SUBJECT: **R.E. Ginna Nuclear Power Plant**
Docket No. 50-244

Request For Additional Information Regarding Generic Letter 2004-02

Ginna LLC Response to Request for Additional Information
Regarding GL 2004-02, Dated December 4, 2009

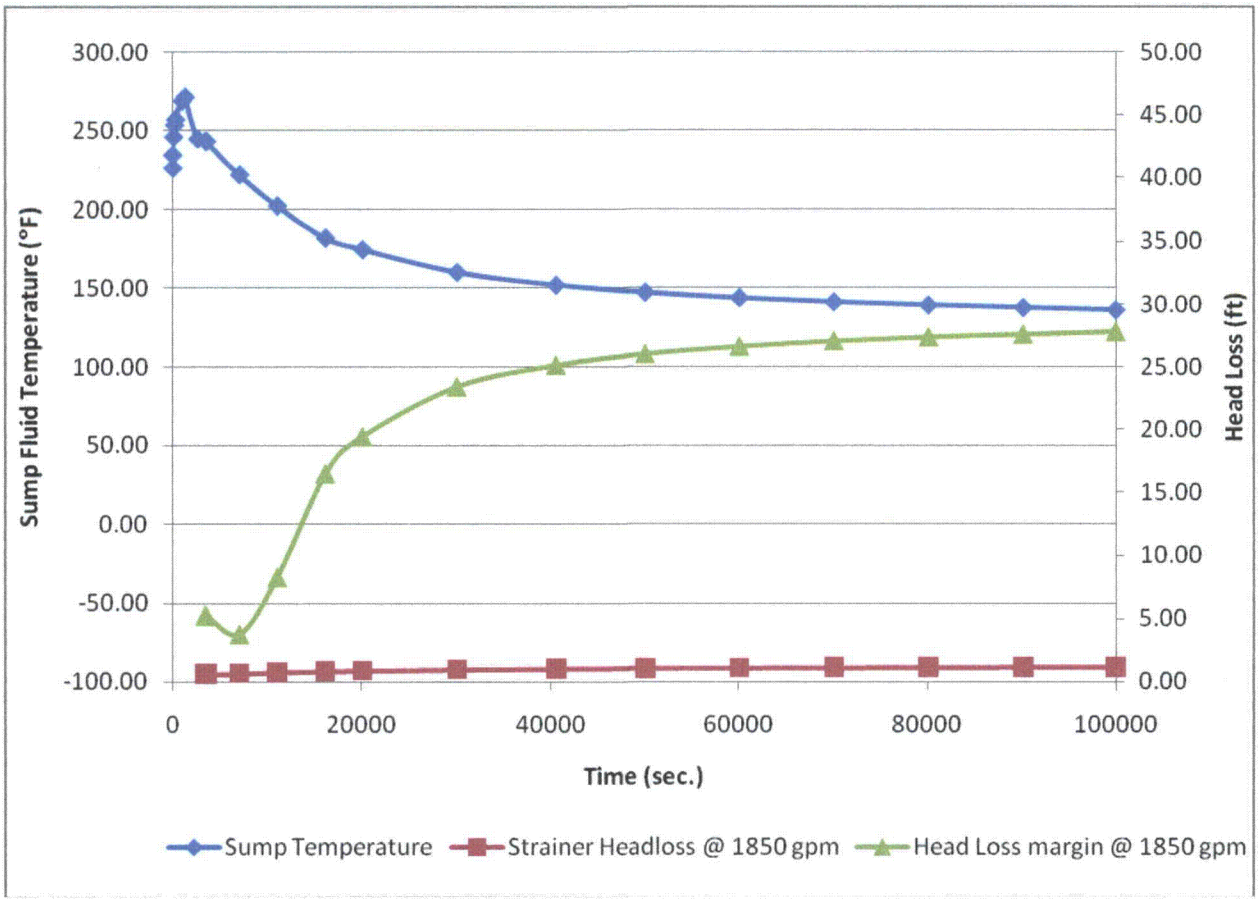
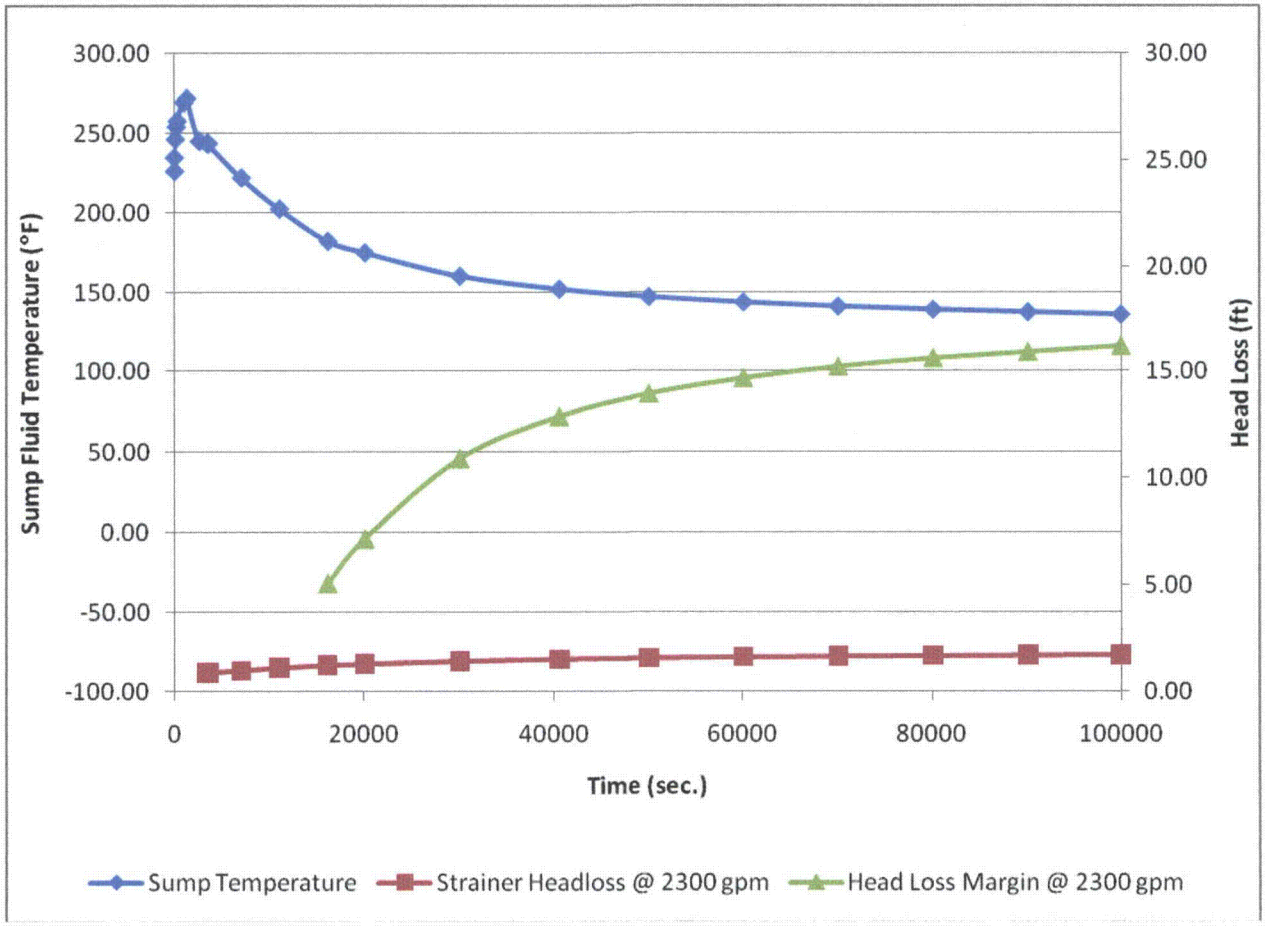
The clean strainer head loss calculation was apparently conducted at 195 °F. It is likely that the clean strainer head loss at lower temperatures would be higher. The licensee should verify that the head loss evaluation considers the potential for higher clean strainer head loss later in the event when the sump temperature is likely to be colder.

The clean strainer head loss was determined through head loss testing. It was determined to be 0 mbar at the scaled equivalent of 2300 gpm and approximately 65 °F [7]. The sump strainer connecting ducts and channel head loss was determined by calculation to be 3.91 mbar (0.131 ft) at the scaled equivalent of 2300 gpm and 195 °F [7]. The following sump strainer head loss curves, as a function of sump fluid temperature, for two flow rates, include the clean strainer head loss, the head loss due to full debris load, and the head loss due to connecting ducts and channels. The two flow rates depicted bound the large break and small break sump recirculation flow cases (1850 gpm), and the long term recirculation to prevent boron precipitation (2300 gpm). Overlaid on each curve is the RHR pump NPSH margin for that case. As shown below, the rate of increase in NPSH margin is greater than the increase in strainer head loss, as sump fluid temperature decreases. This results in greater NPSH margin later in the event.

NPSH Margin vs Strainer Head Loss at 1850 gpm
Head Loss (ft)
35.00
30.00
25.00
20.00
15.00
10.00
5.00
0.00
70 80 90 100 110 120 130 140 150 160 170 180 190 200 210 220 230 240 250
Temperature (°F)
Head Loss @ 1850 gpm
LBLOCA NPSH Margin
SBLOCA NPSH Margin

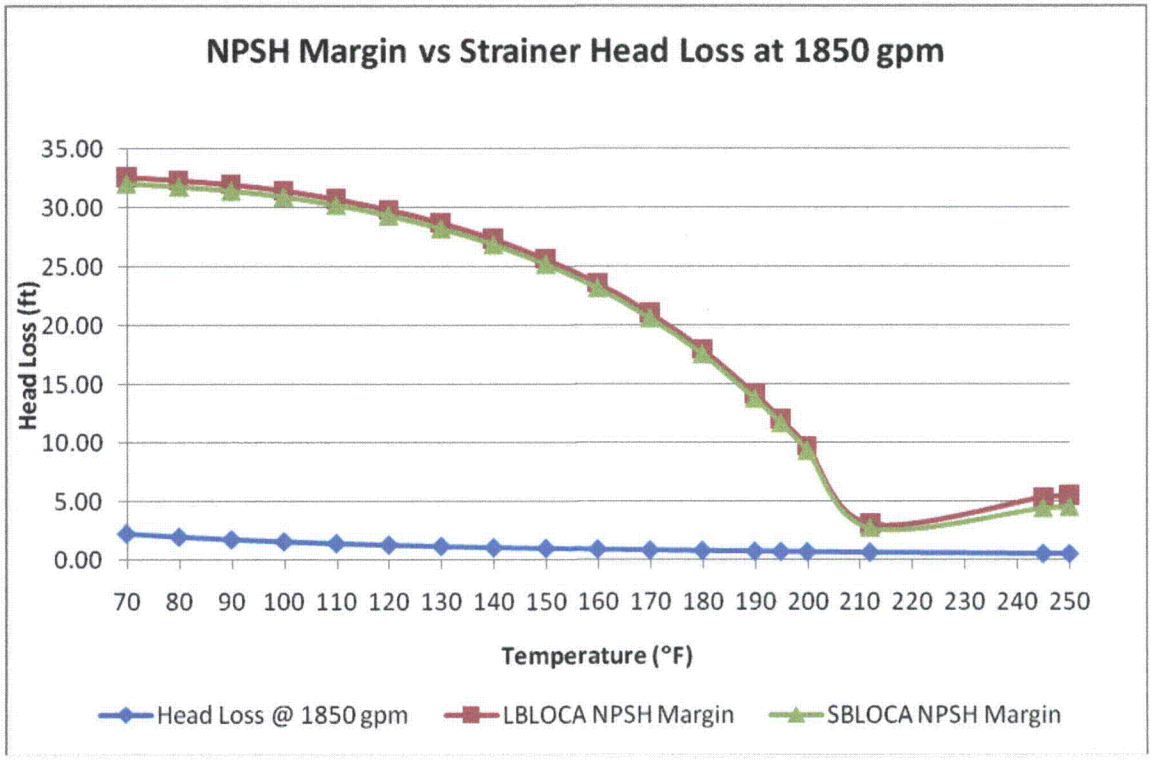
2. The supplemental response provided a debris head loss value stated to be 0.99 feet when corrected to a "minimum sump temperature" of 195 °F. It was not clear what head loss value was applied at colder sump temperatures that would occur later in the event or whether the value was corrected further for hotter conditions. The staff did not understand what was meant by "minimum sump temperature" as used in this context. The licensee should either calculate the head loss at the minimum sump temperature predicted for the event and apply this value to the NPSH margin calculation, or provide a time/temperature dependent NPSH margin evaluation that justifies that adequate NPSH margin is available for all pumps taking suction from the containment sump for the plant's potential range of post-LOCA conditions.

The sump strainer head loss of 0.99 ft (29.7 mbar) is the head loss due to the clean strainer and full debris load, including chemical effects, at 195 °F. It does not include the added head loss from the sump strainer internal connecting ducts and channels. The head loss due to sump strainer internal connecting ducts and channels results is an additional 0.131 ft of head loss at 195 °F.
